FINAL DRAFT MINUTES

September 20, 2012 Standards Committee Meeting

RE: Minutes from the September 20, 2012 Standards Committee Meeting

EXISTING 706-TTFC-03 CONCRETE BRIDGE RAILING TRANSITION, TFC (WITH MARKUPS)

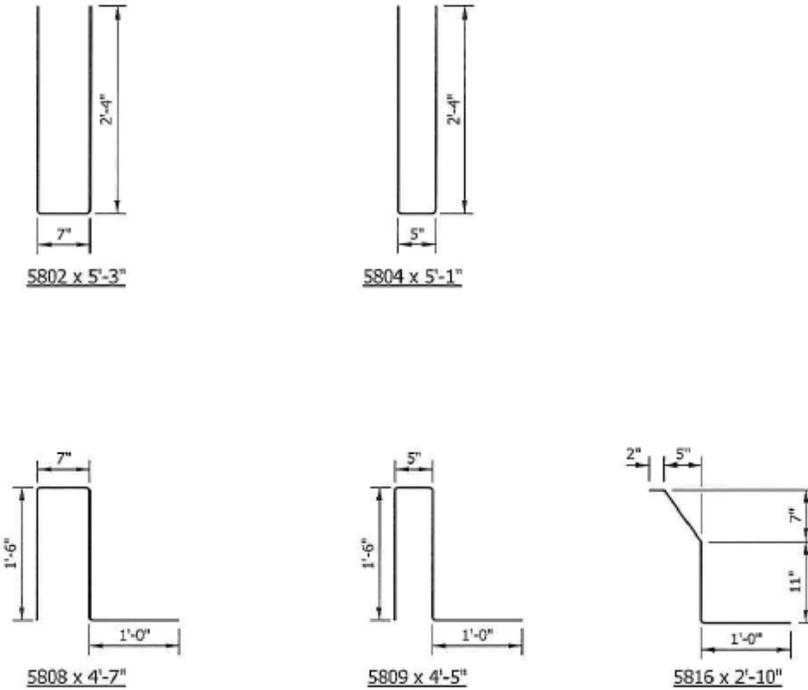
PROBLEM(S) ENCOUNTERED: A review of Standard Drawing 706-TTFC-01 through -03 revealed an error in the location of a section and consequently, an incorrect bill of materials.

DISCUSSION: Ms. Phillips presented this item as shown and as described in the proposal page, and made a motion that this item be approved as submitted. Mr. Cales seconded that motion. Ms. Phillips then explained the revisions as shown attached above, and how the bill of materials is affected. A minor revision was recommended for section C-C, that the longitudinal bars should not be shown. Ms. Phillips will have that corrected.

BILL OF MATERIALS			
Quantities are for one concrete bridge railing transition type TFC			
EPOXY-COATED REINFORCING STEEL			
MARK OR SIZE	NO. OF BARS	LENGTH	WEIGHT
5802	12	5'-3"	
5804	19	5'-1"	
5808	12	4'-7"	
5809	19	4'-5"	
5816	11	2'-10"	
#5	10	10'-9"	
#5	1	6'-9"	
#5	14	6'-0"	
Total Epoxy-Coated Reinforcing Steel			551 LBS
MISCELLANEOUS			
Concrete, Class C			1.2 CYS
Surface Seal			100 SFT
